PERMIT AND VICINITY MAP
SHANNON, LLC
SHANNON MINE
P-3859 / REVISION R-17
MAP 1 OF 2

Part of Sections 1, 2, 3, 4, 9, 10, & 11, Township 20 South, Range 6 West, Part of Sections 25, 35 & 36, Township 19 South, Range 6 West, Part of Sections 1 & 2, Township 19 South, Range 5 West.
Jefferson and Tuscaloosa Counties, Alabama

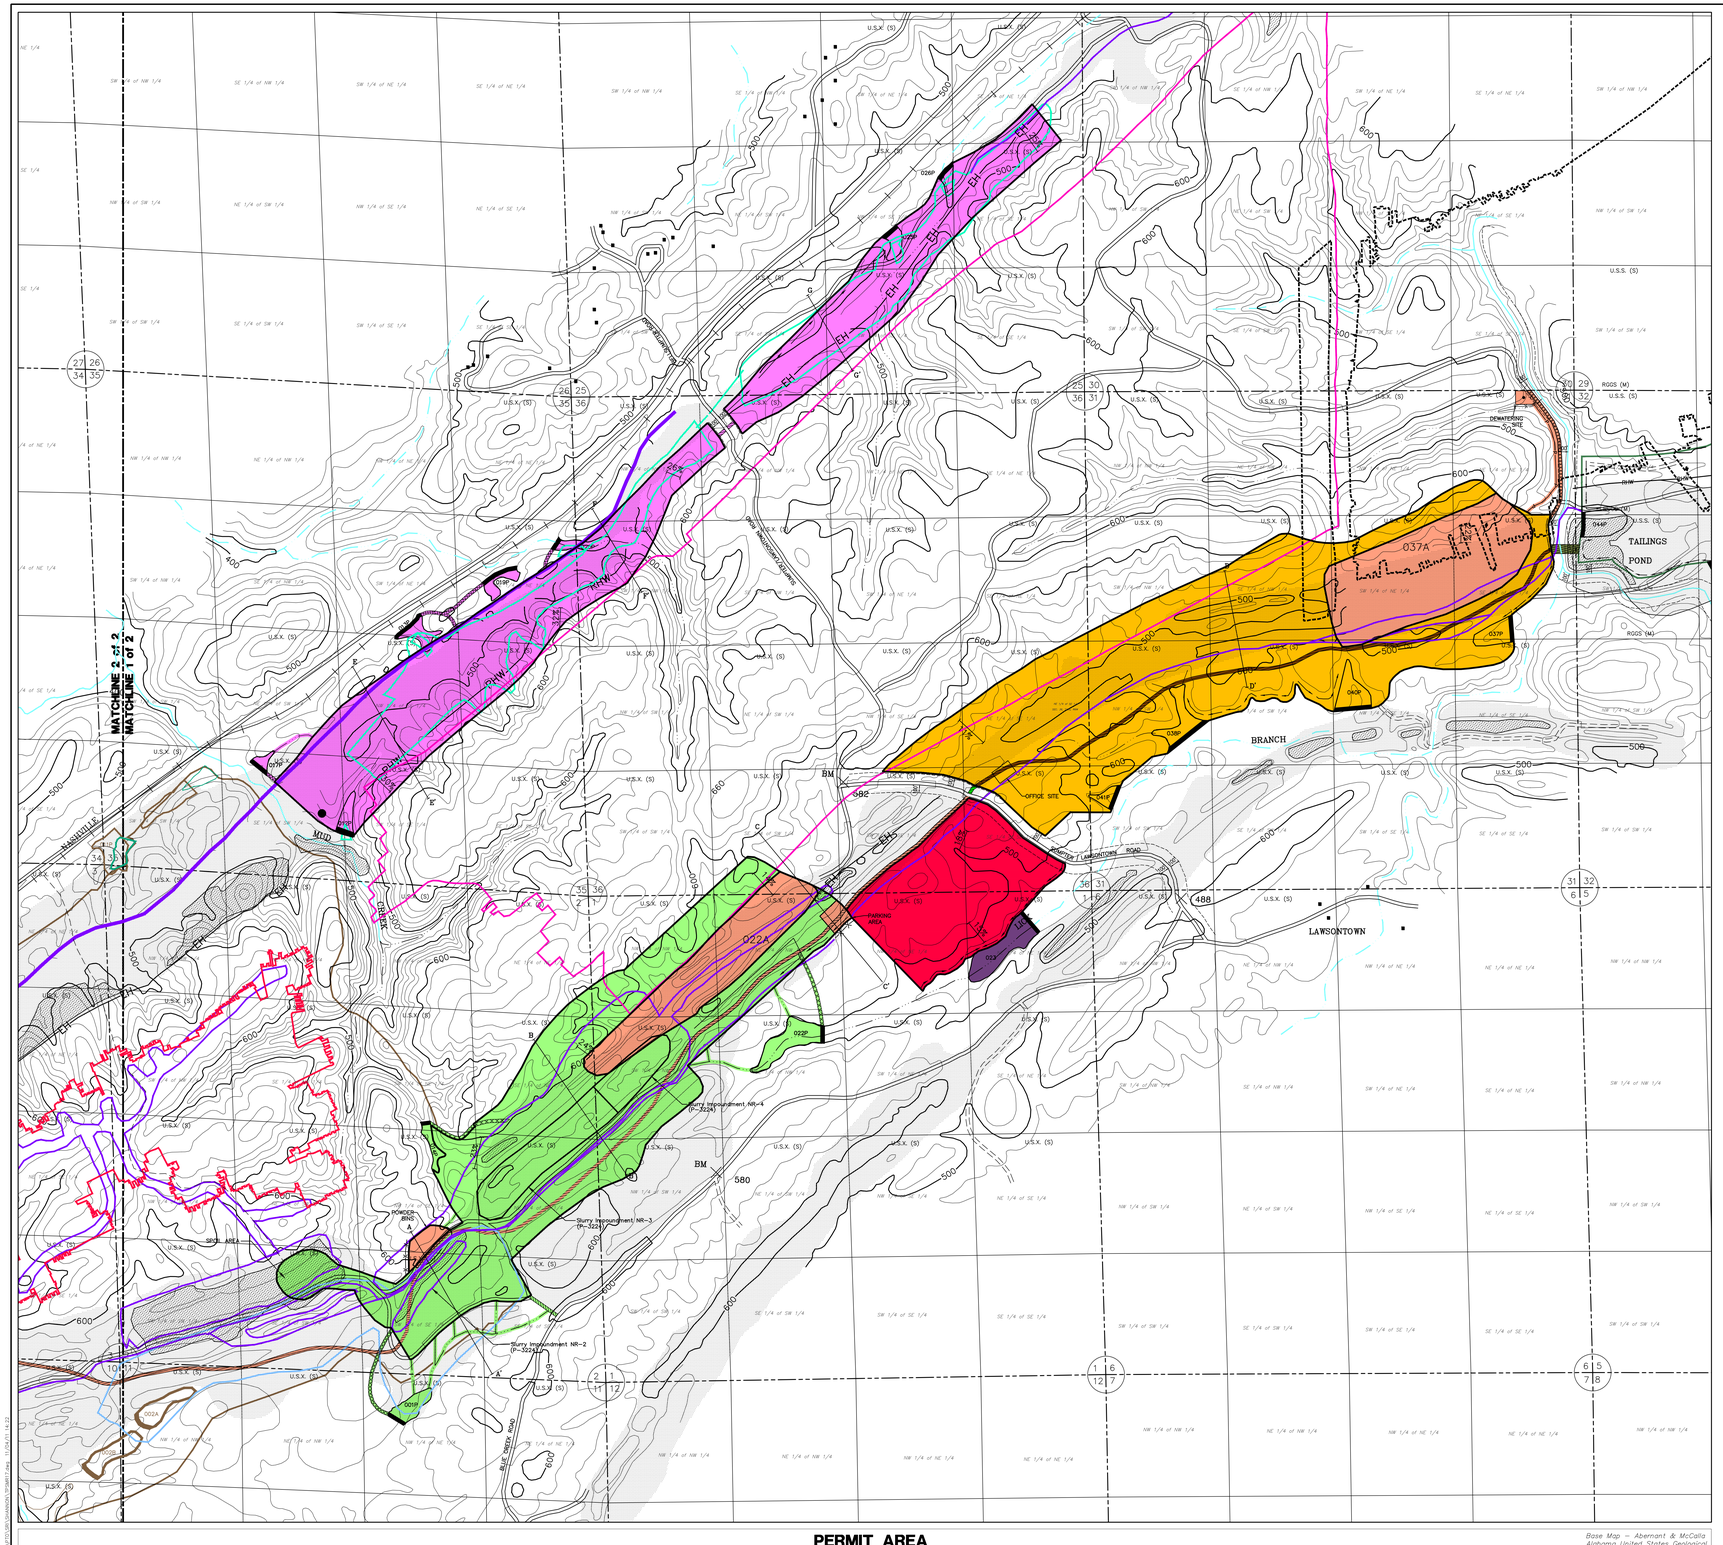
- Add 58.0 incidental acres (warehouse/maintenance area) to Increment No. 6.
- Add 3.0 incidental acres (Basin 023) to Increment No. 6.
- Add 1.0 incidental acre (low water crossing) to Increment No. 6.
- Transfer 8.0 acres from Increment No. 2 to Increment No. 6 for an extension of Primary Road 7.
- Transfer 0.10 acre (Primary Road 7) from Increment No. 2 to Increment No. 6 (No Acreage Change).
- Update the drainage control plan through the addition of Basin 023.
- Update the Hydrologic Monitoring Plan.
- A request for a delay in Contemporaneous Reclamation for 12 months on the highwall in Increment No. 5, located in the NE 1/4 of SW 1/4 and SE 1/4 of SW 1/4 of Section 9, Township 20 South, Range 6 West, Tuscaloosa County, Alabama.
